RE: Amendment to the Gulf Coast Minimal Impact Mining Permit

**AMENDED ATTACHMENT TO MINIMAL IMPACT NEW MINING OPERATION
IRON DUKE, CINCO DE MAYO, VIRGINIA, AND BARBARA PATENTED CLAIMS
OTERO COUNTY, NEW MEXICO**

**Iron Duke Project
Amended SWPPP**

Plate 2
 Nov., 2017

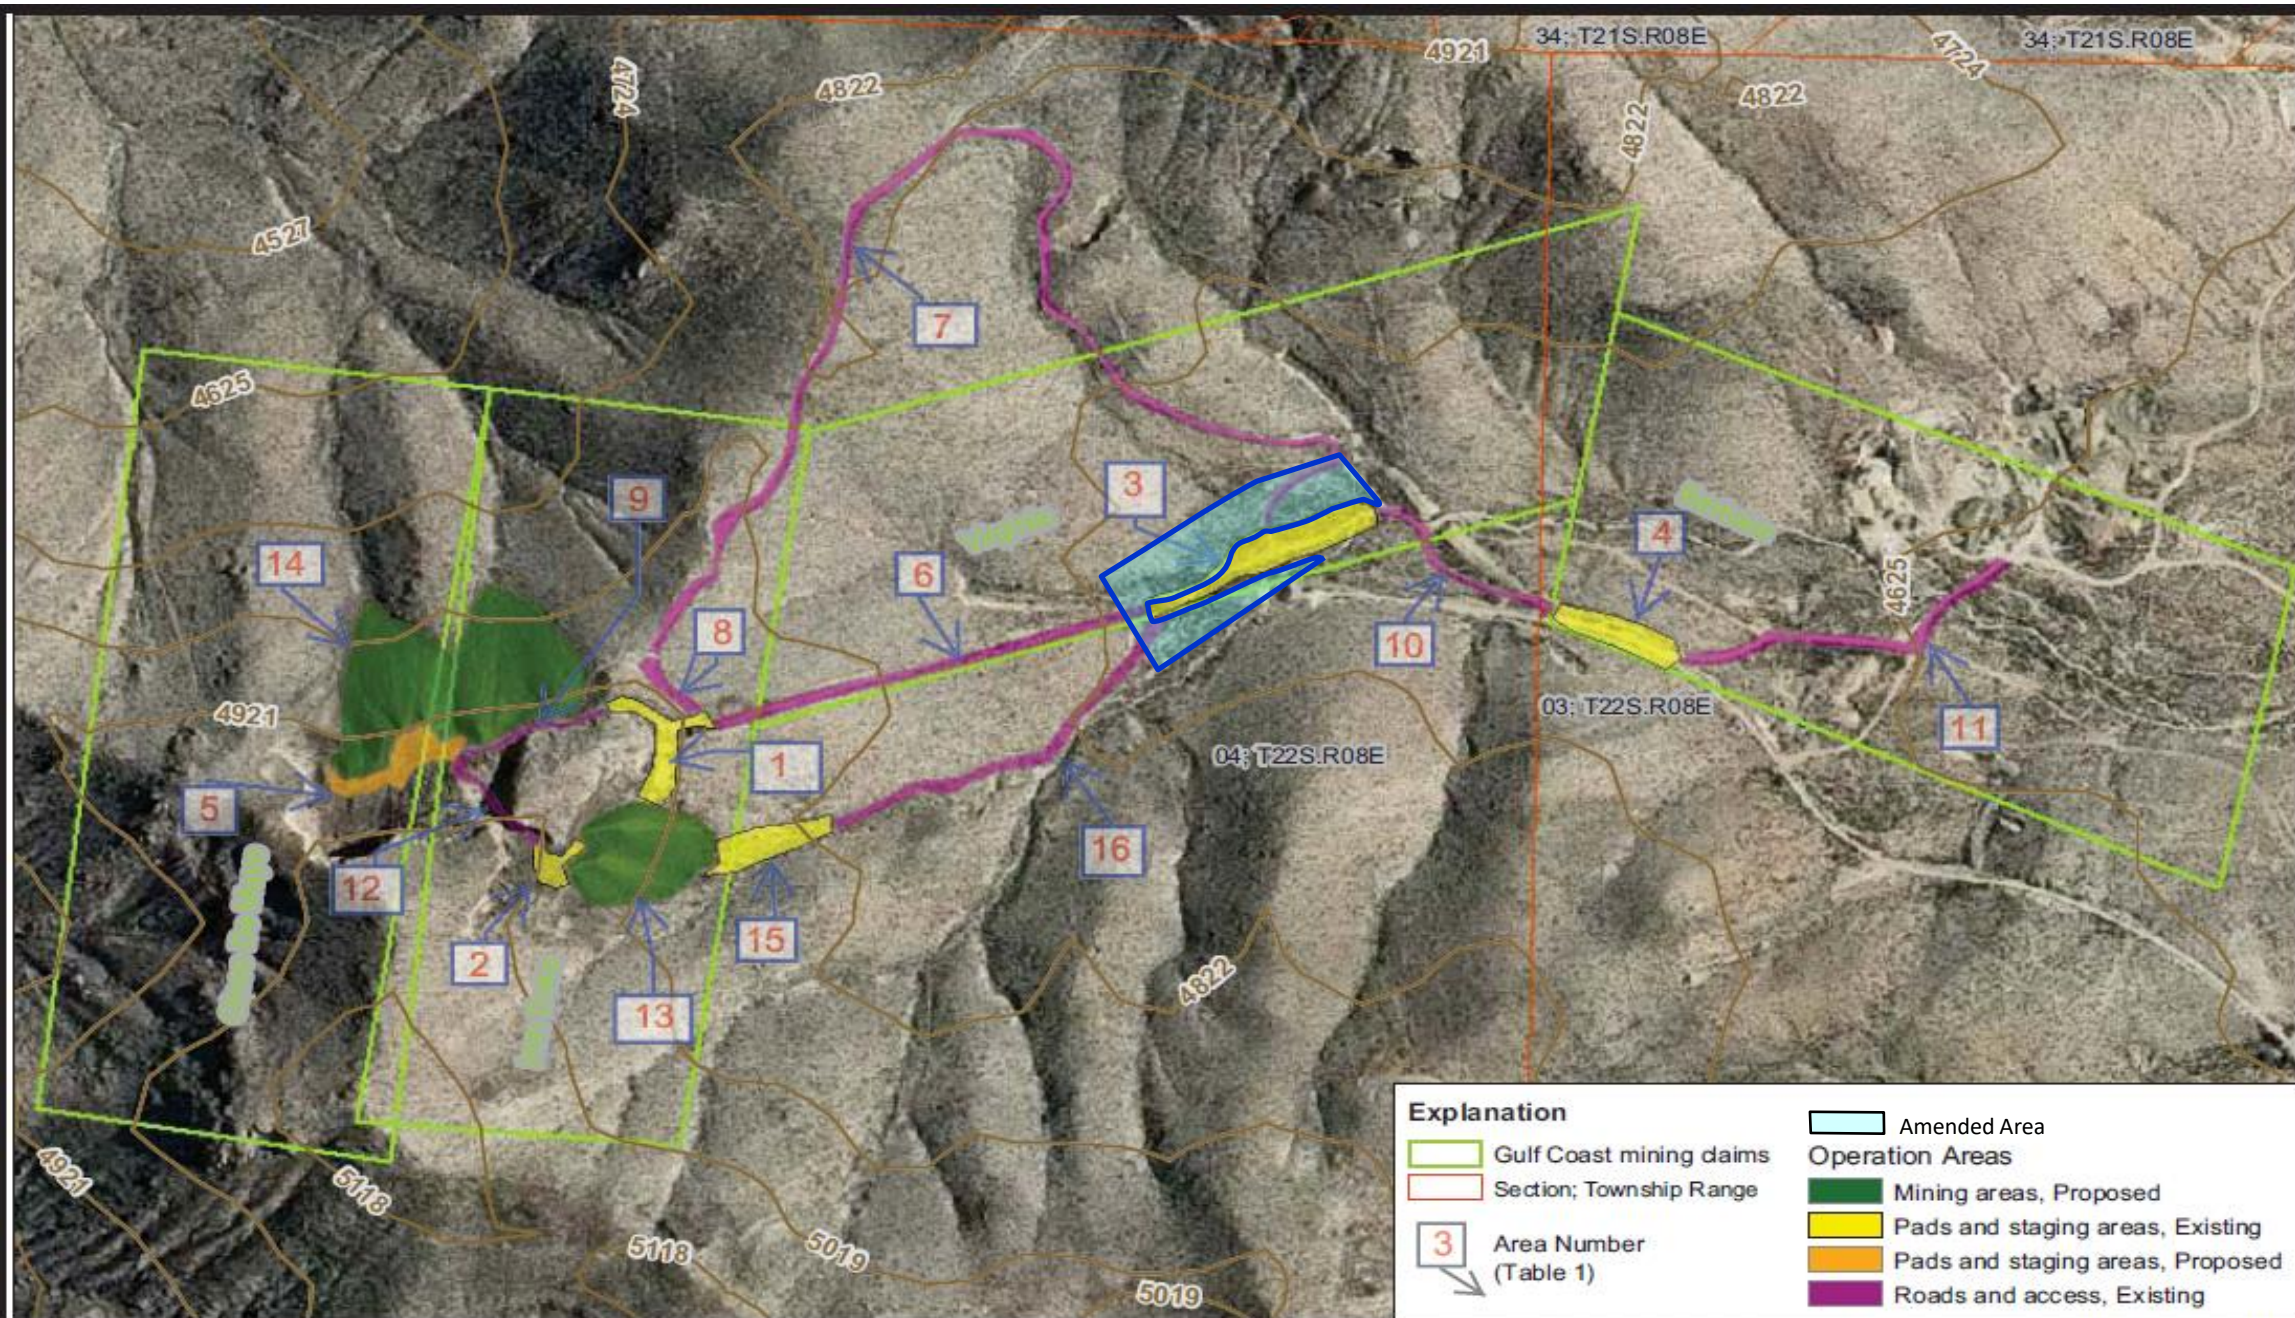
The facilities for the mining/reclamation operation are described below, identified in Plates 2 and 3, and presented in tabular form in Table 1. The Area Numbers shown in the left column of Table 1 are plotted on Plate 3.

Pad 3 is the proposed location for the processing to occur. This pad was originally 0.56 acres in area. The enlarged area is 1.86 acres in area. Hence, the pad is enlarged by 1.30 acres in area. This results in an amended total area disturbed, reclaimed and improved of 9.18 acres.
